OGMCOAL - Crandall Canyon Inspection Report: 5/15/2012

Inspection Report

Permit Number:	C0150032
Inspection Type:	PARTIAL
Inspection Date:	Tuesday, May 15, 2012
Start Date/Time:	5/15/2012 1:30:00 PM
End Date/Time:	5/15/2012 3:30:00 PM
Last Inspection:

Permitee: **GENWAL RESOURCES INC**
 Operator: **GENWAL RESOURCES INC**
 Site: **CRANDALL CANYON MINE**
 Address: **PO BOX 910, EAST CARBON UT 84520-0910**
 County: **EMERY**
 Permit Type: **PERMANENT COAL PROGRAM**
 Permit Status: **ACTIVE**

Disturbed Drainage Ditch DD-10
Note debris in diversion
Genwal Representatives instructed to
clean out.

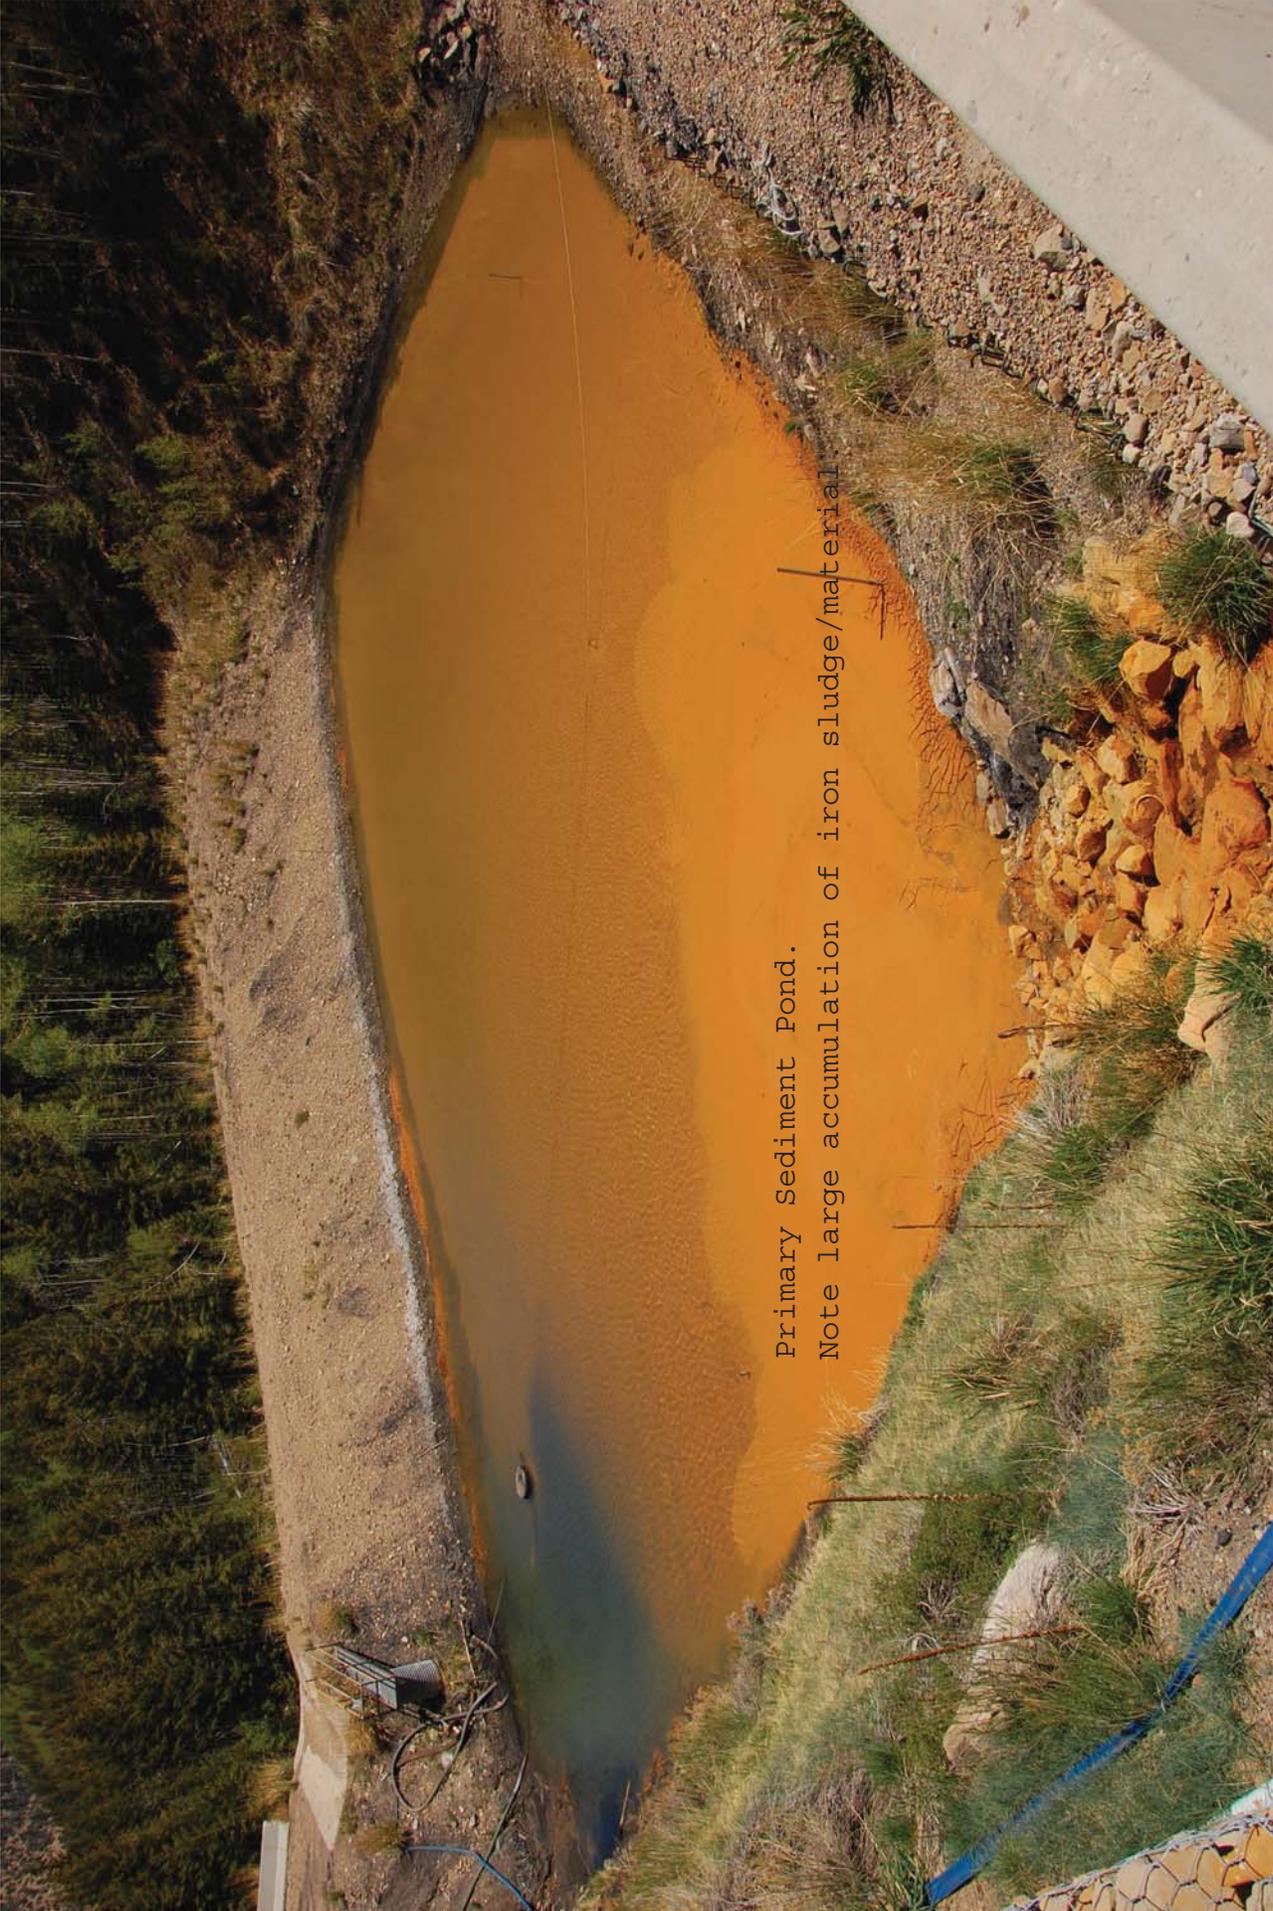
Upon inspection of disturbed drainage ditch DD-10 (located directly adjacent to the east end of the treatment basin), rock and coal material from the overhanging highwall was observed. Mr. Leonard and Mr. Marshall were instructed to remove the debris from the diversion.

Primary Sediment Pond.
Note large accumulation of iron sludge/material.

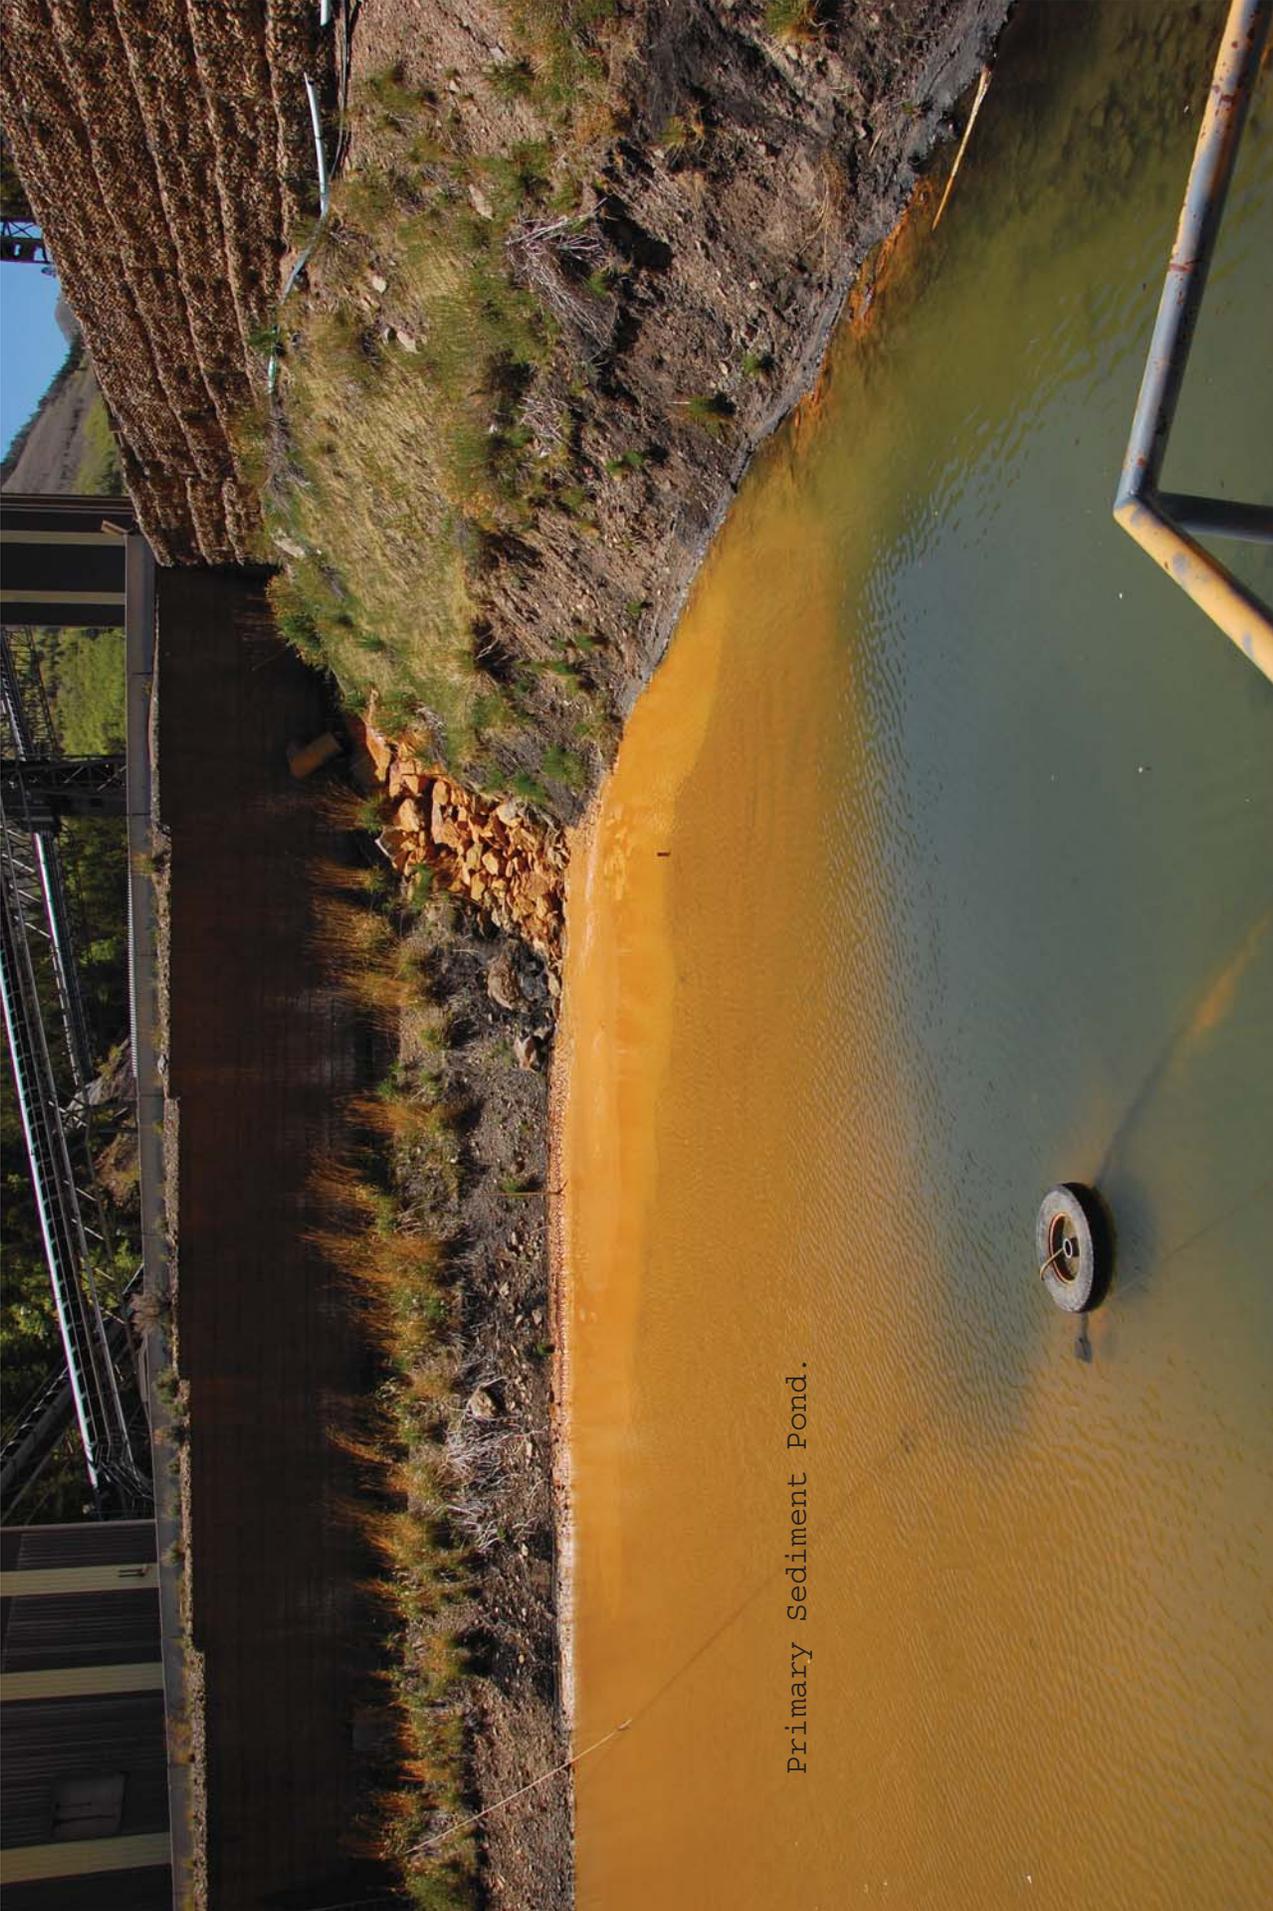
The primary sediment pond was observed during the inspection. A large accumulation of iron sludge material was observed at the inlet to the pond. The two sediment clean-out markers were observed to be buried by the accumulated sludge material. Mr. Marshall and Mr. Leonard were instructed to have the primary sediment pond cleaned as it appears that the clean-out level had been surpassed by the accumulated iron sludge material.
